Proposed Mosque and Community Facilities
Croudace Road, Elmore Vale
Peer Review 2 - Acoustics

Report Number 630.10171-R2

20 July 2011

Peer Review 2 - Acoustics

Figure 1 – Receiver Locations

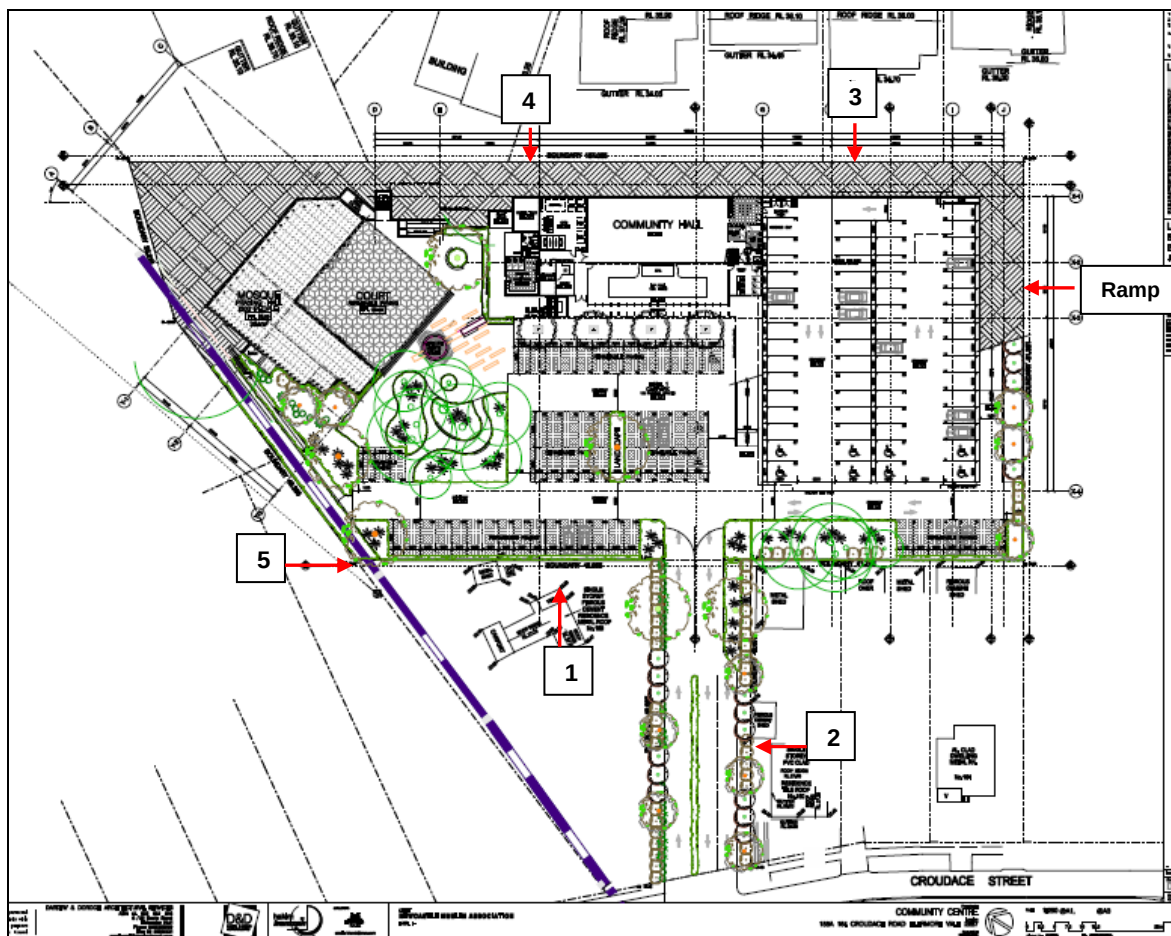
The typical operating scenario utilised for the purpose of assessing noise levels is considered conservative and representative of an acoustically worst-case situation however, it is noted that noise from the ramp is not included in Tables 5 and 6. (Also refer to **Section 3.6** with regard to noise from the ramp.) Furthermore, there is potential for noise from the ramp to have a significant contribution at the residence immediately east of Receiver 3. It is recommended that noise from the ramp be included in the cumulative noise assessment at all receivers including an additional receiver point at the residence immediately east of Receiver 3.

Cumulative noise levels from a typical daytime operating scenario at the Ramp receiver are presented in Table 13 of Spectrum Acoustics letter dated 30 May 2011. This table presents a predicted noise level ($L_{Aeq}(15\text{minute})$) of 41 dBA from Car Park (parks 16-21). It is not apparent where the noise level has been predicted; what distance from the boundary, on ground level or at the balcony? Table 3 of Spectrum Acoustics report dated 21 March 2011 presents a predicted $L_{Aeq}(15\text{minute})$ noise level of 47 dBA at the rear balcony of this receiver from the Car Park only (parks 16-21).

It is recommended that further information be supplied to clarify the location of the assessment point and the predicted cumulative noise level at this location.

- That noise from the ramp be included in the cumulative noise assessment at all receivers including an additional receiver point at the residence immediately east of Receiver 3.

- That further information be supplied to clarify the location of the assessment point and the predicted cumulative noise level at the Ramp receiver. (Refer to **Section 3.3** for further details.)

Similar calculations to those shown above were carried out for the other receivers shown in Figure 1. The results of the calculations are shown below in **Table 6**.

Table 12 shows a calculation of noise impacts during the day from cars using of the eastern ramp. The calculation has been made to the most potentially affected receiver location marked as ramp on Figure 1.

Figure 2 – Site Cross Section

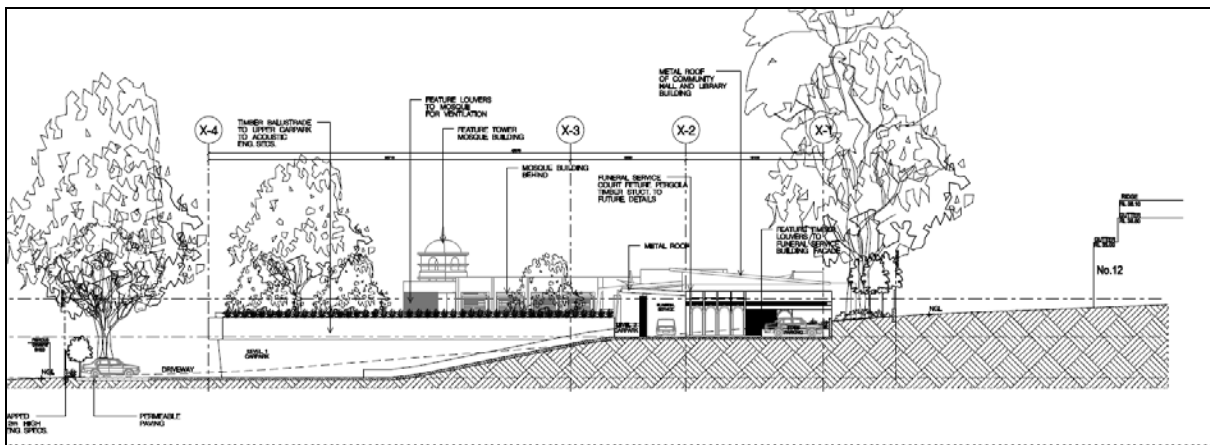
It is recommended that further clarification of this assumption be provided given that the plans of the proposed development show the eastern ramp as an “up ramp” and the western ramp as a “down ramp”. There is potential for the traffic numbers to increase on the ramp if only the “up ramp” is used to access the upper car park.

- That further clarification of the assumption regarding the number of vehicles using the eastern ramp be provided given that the plans of the proposed development show the eastern ramp as an “up ramp” and the western ramp as a “down ramp”.

b) The upper level car park will only be used during the day. It will be closed off at all other times. **Figure 2** shows a cross section through the site which shows that the eastern ramp to the upper level car park rises in cut from existing ground level to the proposed FFL of the car park.

There will be a 2.1m high acoustic barrier along the boundary of the site adjacent to the ramp. Where the ramp rises above natural ground level then there will be a 2.1m high acoustic barrier at the boundary of the nearest residence.
